**Project #19-030
Logan Riverwalk Commercial Building
Locate at 80 East 400 South**

Project Name: Logan Riverwalk Commercial Building
Proponent / Owner: Bracken Atkinson
Project Address: 80 East 400 South
Request: Design Review
Current Zoning: Commercial (COM) & Mixed Use (MU)
Type of Action: Quasi-Judicial
Hearing Date: August 22, 2019
Submitted By: Russ Holley, Senior Planner

Staff recommends that the Planning Commission **conditionally approve** a Design Review Permit for Project #19-030, Logan Riverwalk Commercial Building for a 35,000 SF office building located at approximately 80 East 400 South, TIN #02-054-0054; -0008; -0009; -0043.

ELEVATION OPTION 01

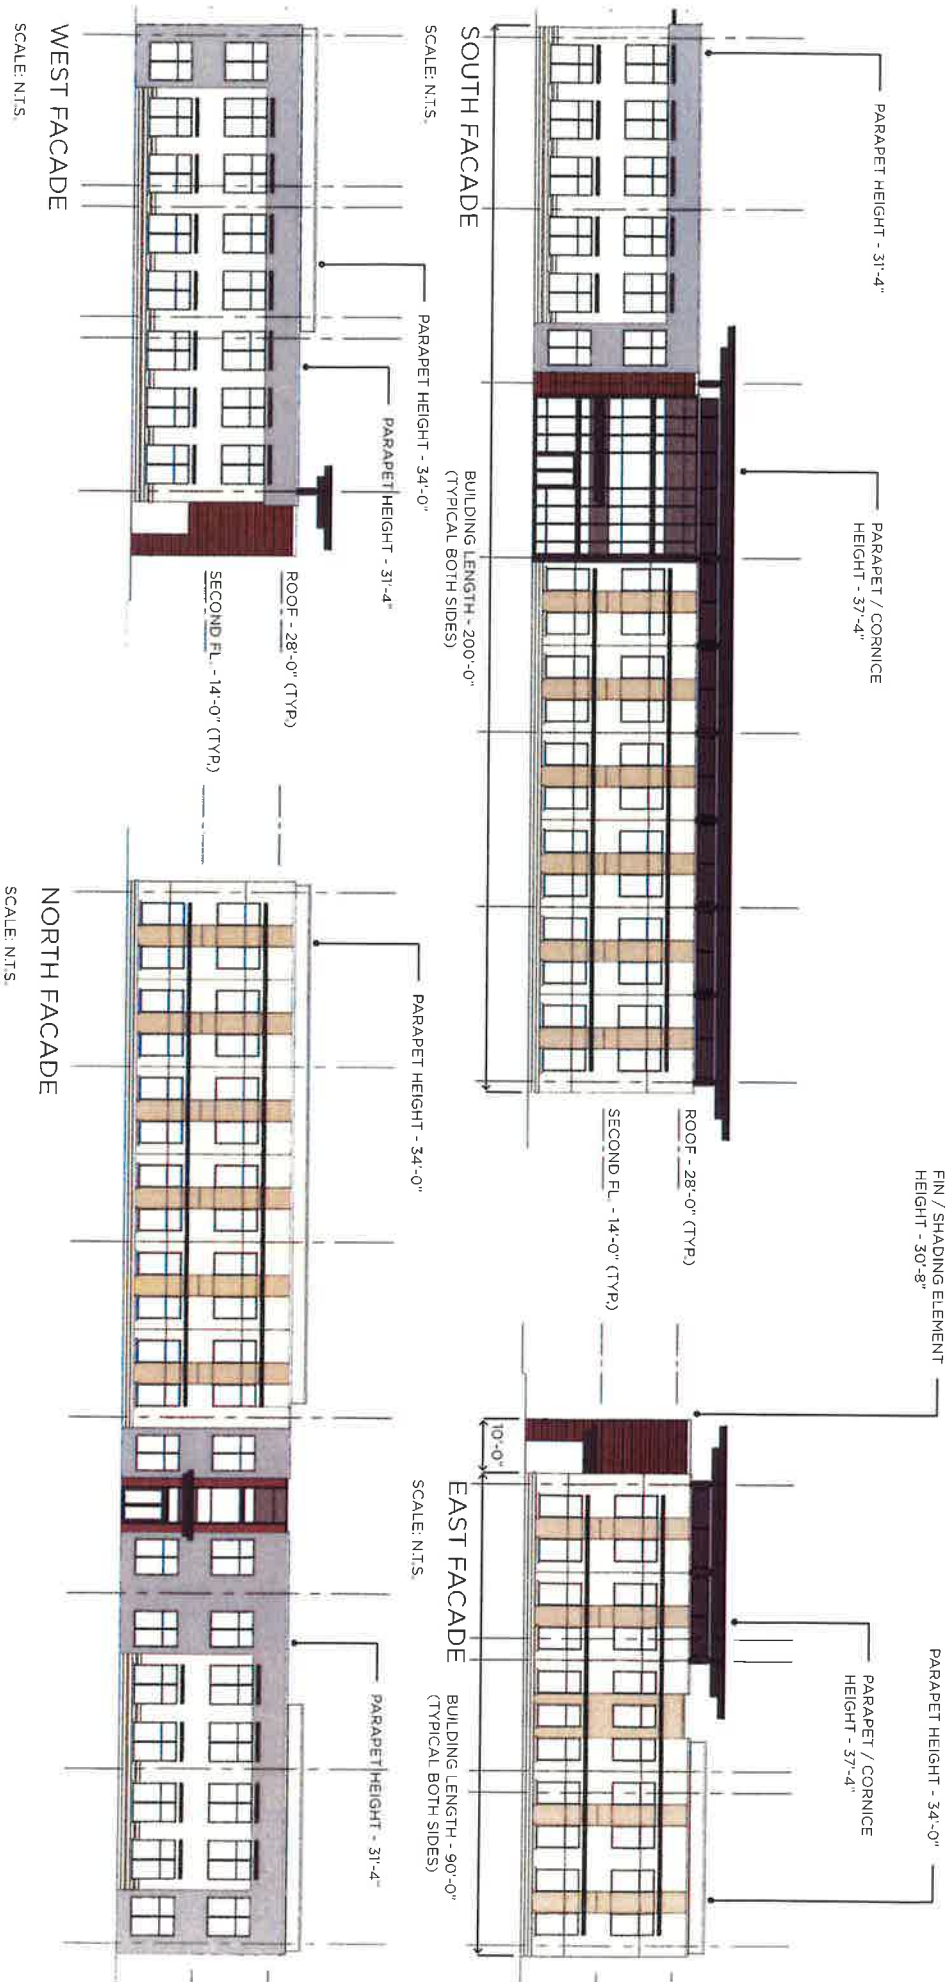
The proposed building meets minimum transparency requirements in the LDC. The rear façade adjacent to the parking lot has an entry feature with an additional significant amount of glass creating a building design that is not considered 4-sided architecture. As conditioned with architectural features and transparency levels similar on all 4-sides, the project complies with the requirements in the LDC.

The LDC allows for buildings to have primary entrances not oriented towards the street if the building façade facing the street has similar architectural features and as the primary entrance/façade. The commercial building has an entry on the front façade adjacent to 400 South street but does not contain similar architectural features found on the rear façade facing the parking lot. As conditioned with similar entryway architectural features in the front and back, the project complies with the requirements in the LDC.

4. The building shall have 4-sided architecture with rear façade architectural features matching front facades. All entryways shall have minimum weather protections and features that emphasis inviting entrances.

5. All frontage and exposed ground floor sides shall meet 30% transparency requirement.
6. A minimum of 116 parking stalls shall be provided for the office at a ratio of one (1) parking stall per every 300 SF of office space. A bike rack shall be installed on-site for bike parking.

C-101

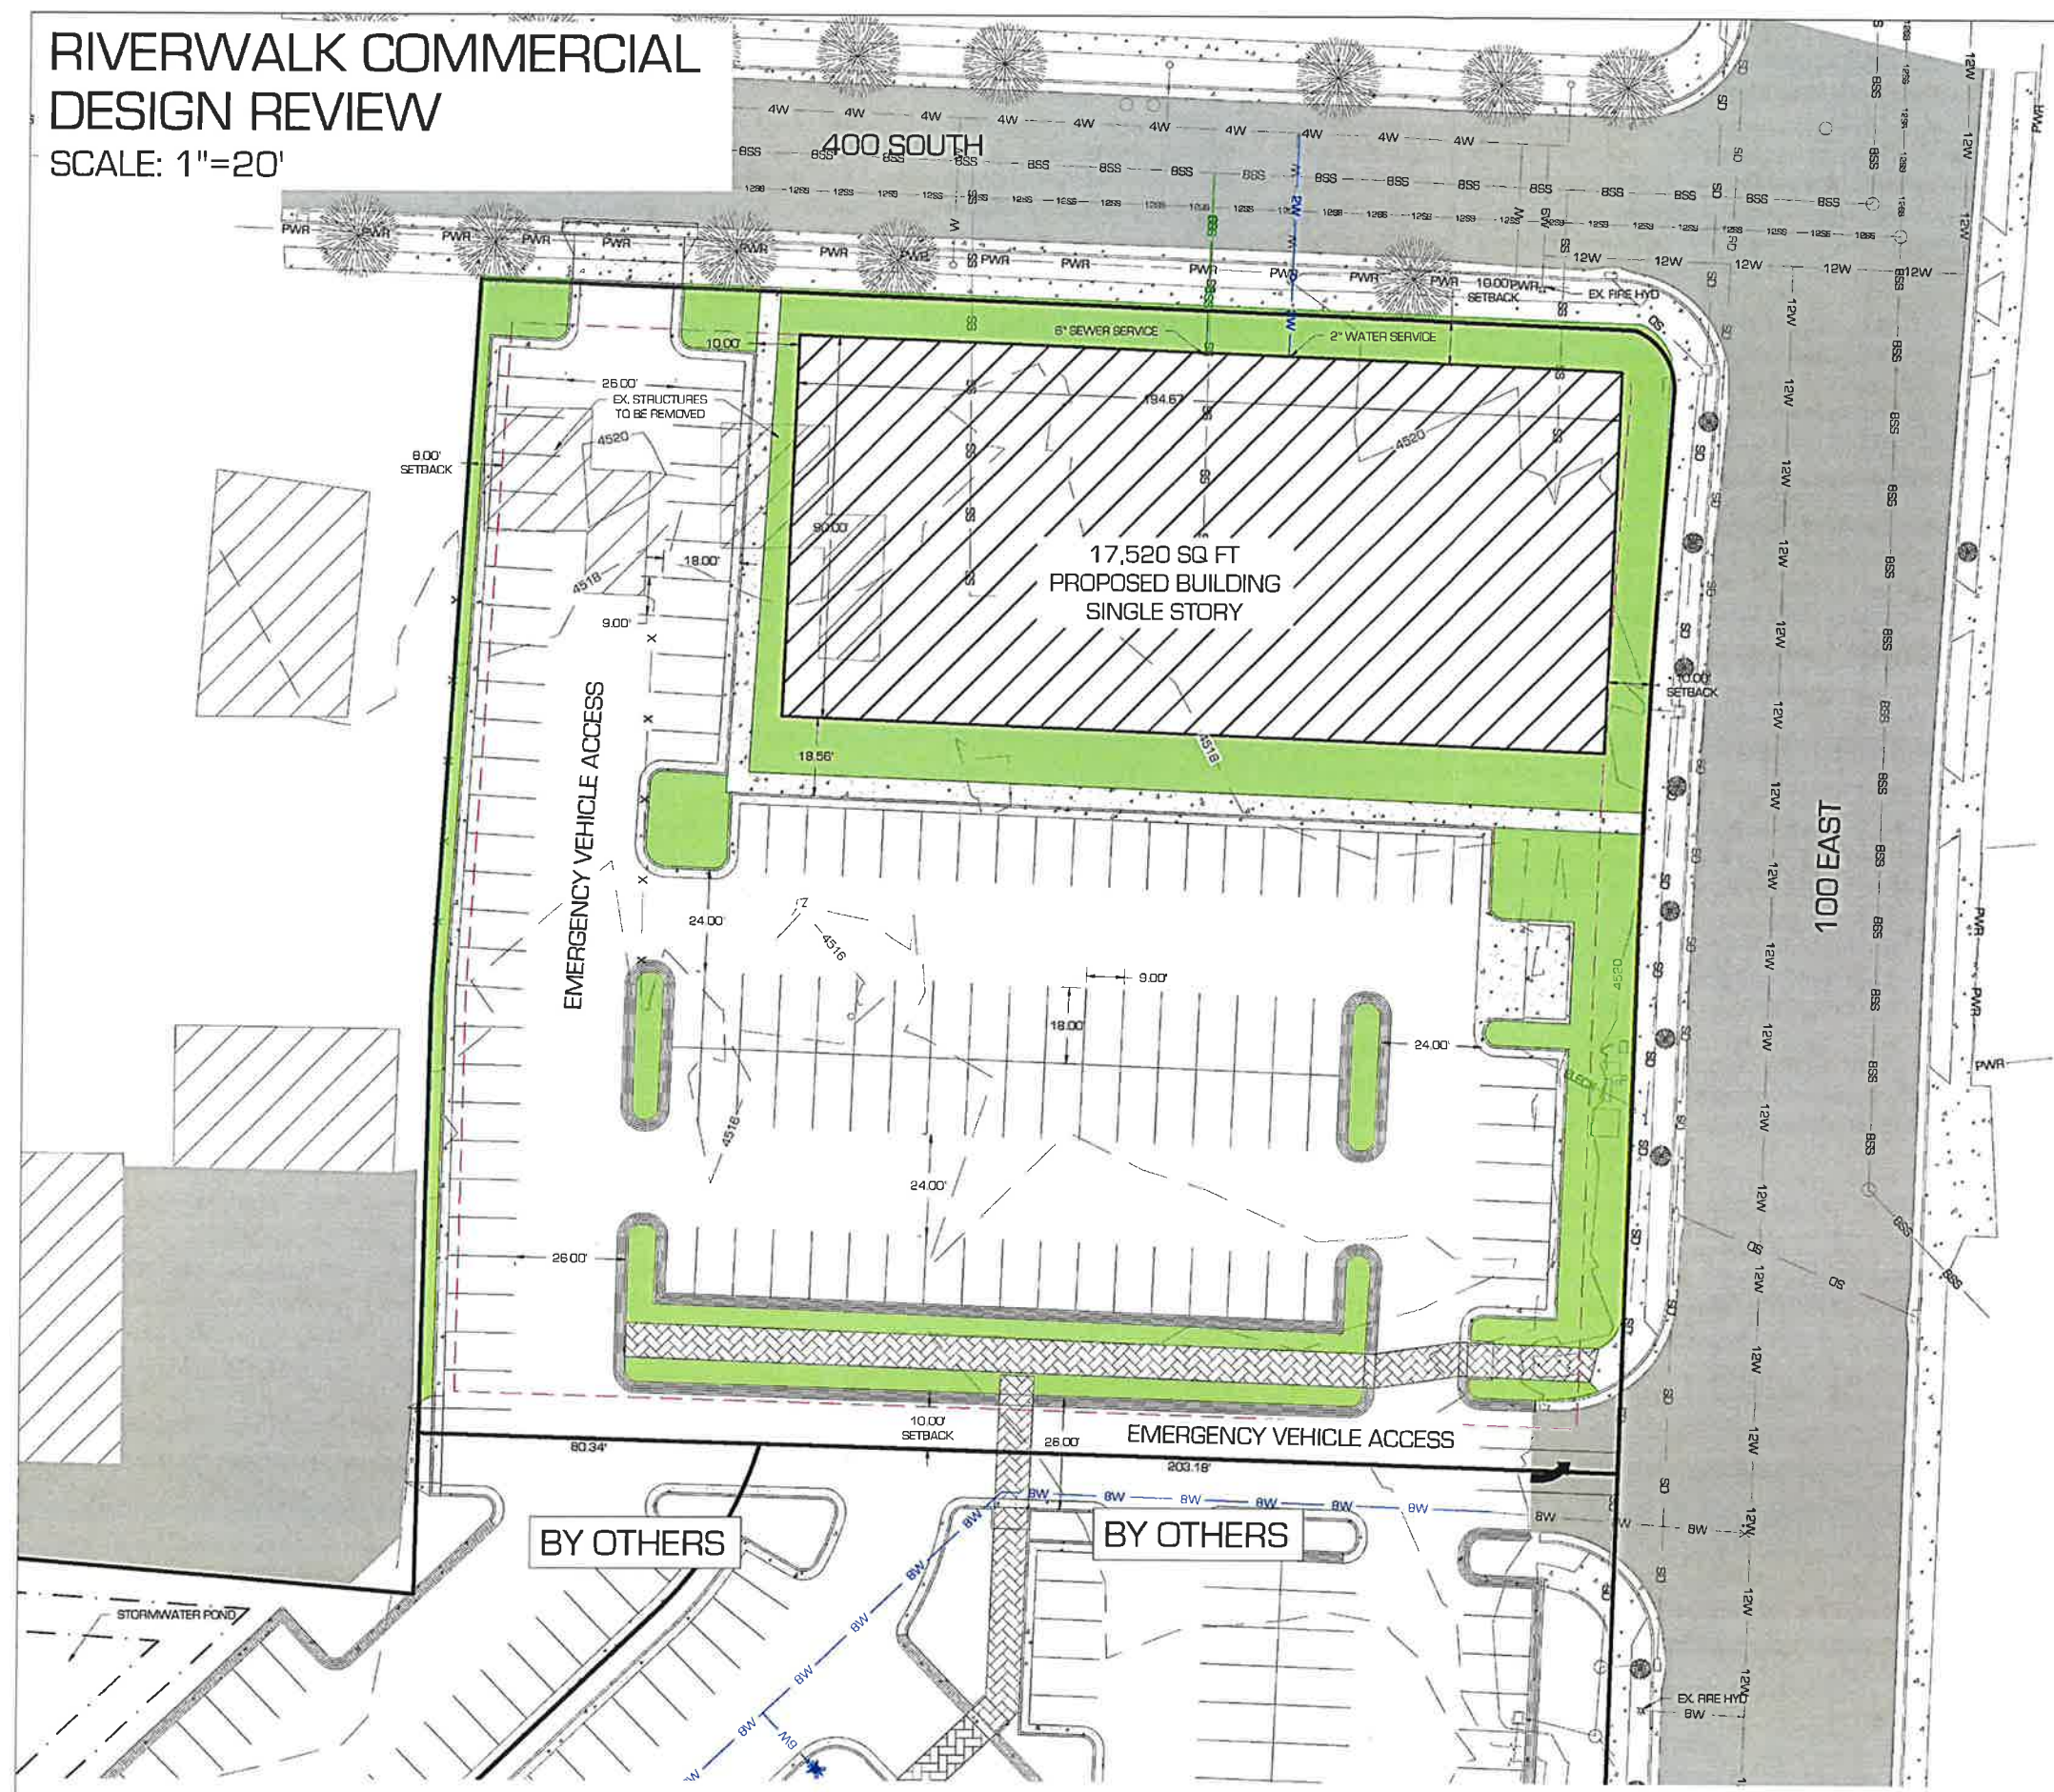
As conditioned with the enhanced front and corner setbacks of 25’ and 20’ in areas adjacent to NR zoning, the project complies with the requirements in the LDC.

The Commercial zone requires a minimum 50% building frontage at front setback. As proposed, the commercial building frontage along 400 South is approximately 70% (194' building/240' lot width). Vehicular access and circulation are proposed on both 400 South and 100 East. The driveways are located away from the intersection and internal circulation allows for cross-flow between other Riverwalk buildings and services. Pedestrian access is from both 400 South and 100 East and sidewalk networks allow for walkability throughout the project. As conditioned with sidewalk network connections throughout the project site, the project meets the requirements in the LDC.

For an office, the LDC 17.31 requires vehicular parking at one (1) parking stall per every 300 SF of office space. At approximately 35,000 SF of office space, 116 parking stalls would be required. As proposed, 120 parking stalls are provided meeting LDC requirements. The LDC requires bike racks in commercial areas. As conditioned with minimum parking stalls and a bike rack, the project complies with the requirements in the LDC.

zone. The LDC requires parking lot landscaping in and adjacent to asphalt parking lots at a ratio of 18 SF per every parking stall contained within. For 1.77 acres, 35 trees and 88 shrubs, flowers and ornamental plants would be required as per the LDC. For 116 parking stalls, 2,088 SF of landscaping is required in and adjacent to the parking area. As conditioned with a landscaping plan containing the minimum requirements, the project complies with the LDC.

3. The front yard building setback (north) shall be 25’ and the corner yard building setback (east) shall be 20’ to match the NR zones across the streets.

7. Parking for the commercial buildings will be located in the side or rear yard.
8. A minimum parking setback of 10’ along 400 S is required. A dense landscaping buffer will be constructed between the parking and the sidewalk along 400 S and 100 E. The buffer shall conform with Type “C” Separation LDC 17.32.070.B.

- c) A total number 35 trees and 88 shrubs, perennials and grasses shall be provided.
 - d) 2,088 SF of landscaping shall be placed inside and adjacent to the parking lot areas.
